REMARKS

Amendments to the Drawings

Applicants respectfully request acceptance of the Replacement Figures for Figures 3A, 3B, 5B, 9, 13 and 13 presented herewith. An explanation of the changes is provided as follows.

ANNOTATED DRAWING SHEET SHOWING CHANGES

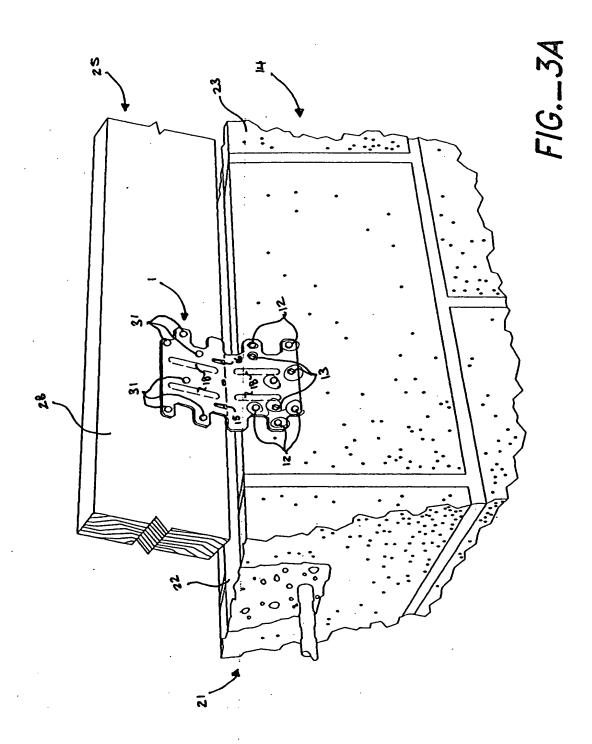
Applicants respectfully request amendment of Figures 3A, 3B, 13A 30 and 13B, to better represent the fasteners 13 and the fastener openings 12 in three dimensions.

Applicants respectfully request additional amendment of Figure 3B to add lead lines and reference numerals 18 to indicate the additional embossments on clip 1. These same embossments are shown and labeled in Figure 3A.

FIG._5B

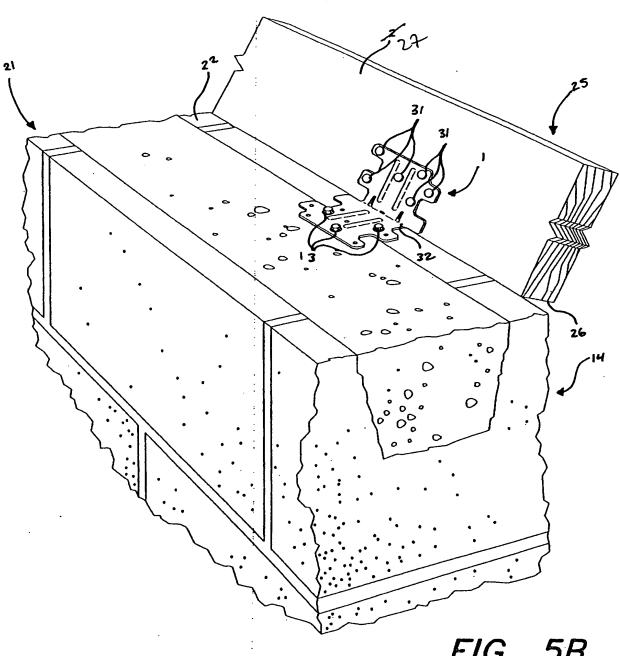
Applicants respectfully request amendment of Figure 5B to change the reference numeral labeling the inner side 27 of the first blocking member 25 from 2 to 27. Figure 1 correctly shows the body 2 of the clip 1 labeled as 2. Figure 4A correctly shows the inner side 27 of the first blocking member 25 labeled as 27.

11/22

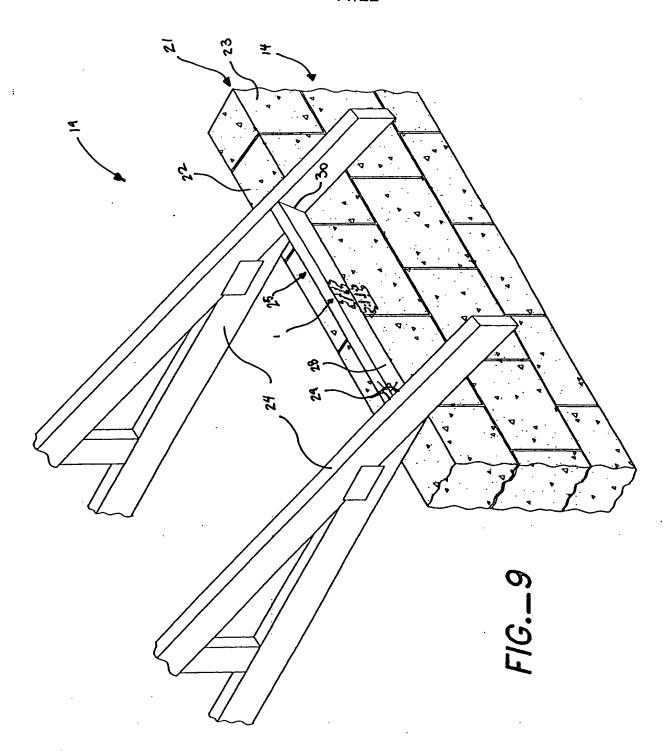
Applicants respectfully request amendment of Figure 9 to change the location to which the lead line indicating the first end 29 of the first blocking 10 member 25 points. This location is shown correctly in Figure 10.
